Environmental Assessment Bear Creek Reservoirs Land Management Plan

FINDING OF NO SIGNIFICANT IMPACT (FONSI)

**ENVIRONMENTAL ASSESSMENT
BEAR CREEK RESERVOIRS
LAND MANAGEMENT PLAN**

Figure SRXB-A.11-1: EPU Power/Flow Map with ICA Regions

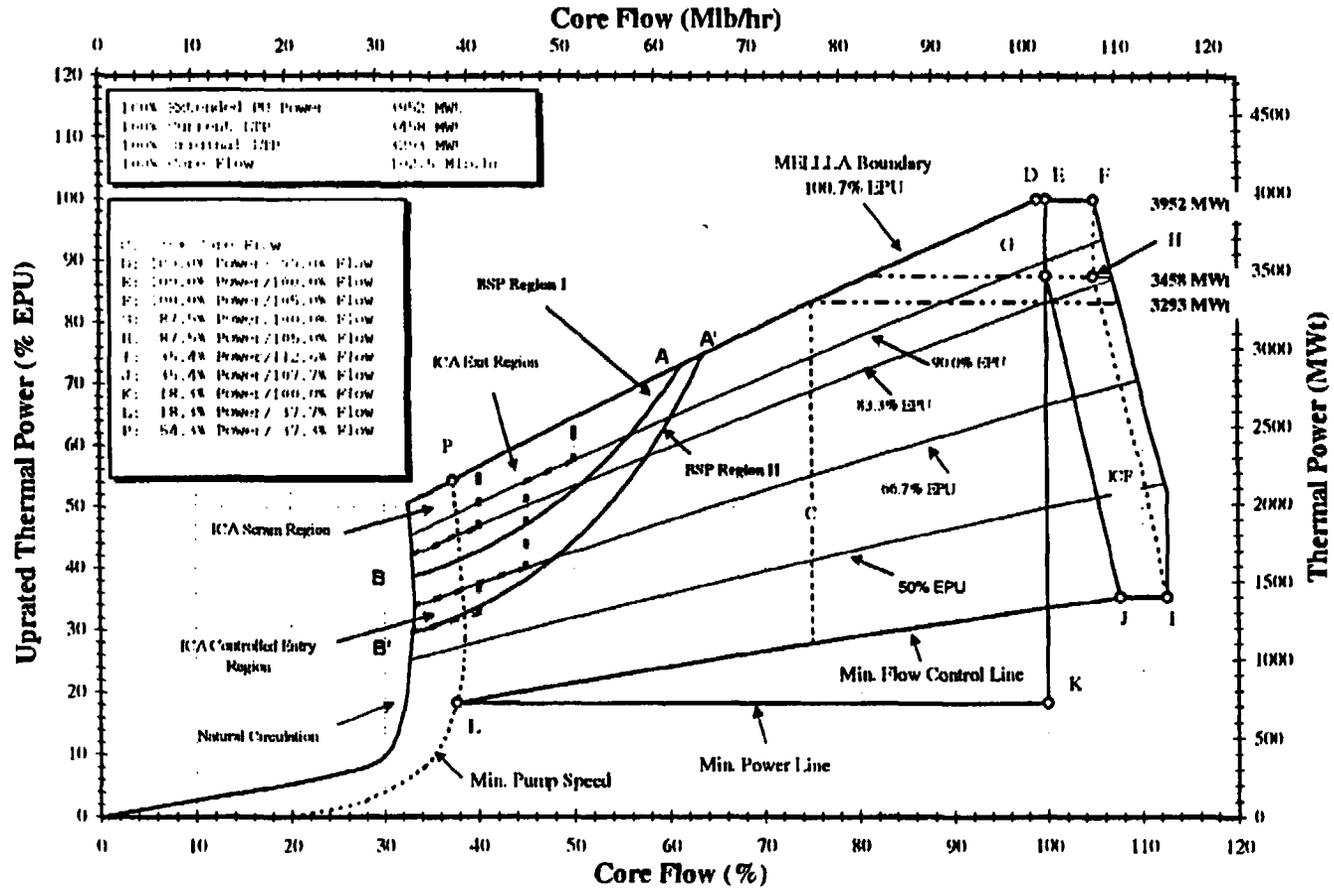
The thermal hydraulic instability exclusion regions are not shown in Figure-1 of Section 2.3.1, Power/Flow Operating Map. Provide the figure showing the instability exclusion regions.

In the proposed technical specification changes, TVA proposed to delete the Thermal Power versus Core Flow Stability Regions Figure 3.4.1-1. Address why this figure is being deleted, including a discussion addressing how the 10 CFR 50.36 requirements for TS will still be met with the deletion of this figure. Also, discuss where this figure will be relocated to and the corresponding document's administrative controls.

The restrictions of the thermal-hydraulic instability exclusion regions in Figure 3.4.1-1, the ICAs, and the parts of TS 3.4.1, Recirculation Loops Operating, related to thermal-hydraulic instability were originally imposed to ensure adequate capability to detect and suppress conditions consistent with the onset of thermal-hydraulic instability oscillations and to limit their probability of occurrence. However, with the installation of the OPRM system, the thermal-hydraulic stability related parts of Unit 1 TS 3.4.1, including TS Figure 3.4.1-1, are no longer required to satisfy 10 CFR 50.36(c)(2)(ii) and are being deleted in TS-443.

The power/flow map is provided as an illustration in General Operating Instructions (GOIs) for unit startup, shutdown, and power maneuvering. Additionally, the power/map is displayed on the plant process computer for operator use.
